# VILLAGE OF EVENDALE

April 2, 2019

RE: Village of Evendale's Response to the Ohio Power Board Staff Report  
On Duke Energy Central Corridor Pipeline Expansion Project  
Case No. 16-253-GA-BTX

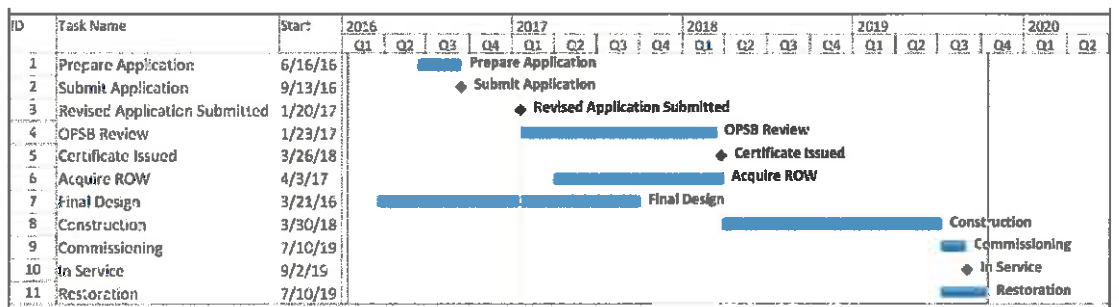
Furthermore, the current C314 Transmission Main, from the Mason Station, operates at 670 PSIG (Maximum Allowable Operating Pressure – MAOP) and wouldn't be difficult to up the pressure of this proposed pipeline system.

**CONDITON #2 - The OPSB should add a condition that the MAOP of 400 PSIG is the maximum that the Central Pipeline can operate.**
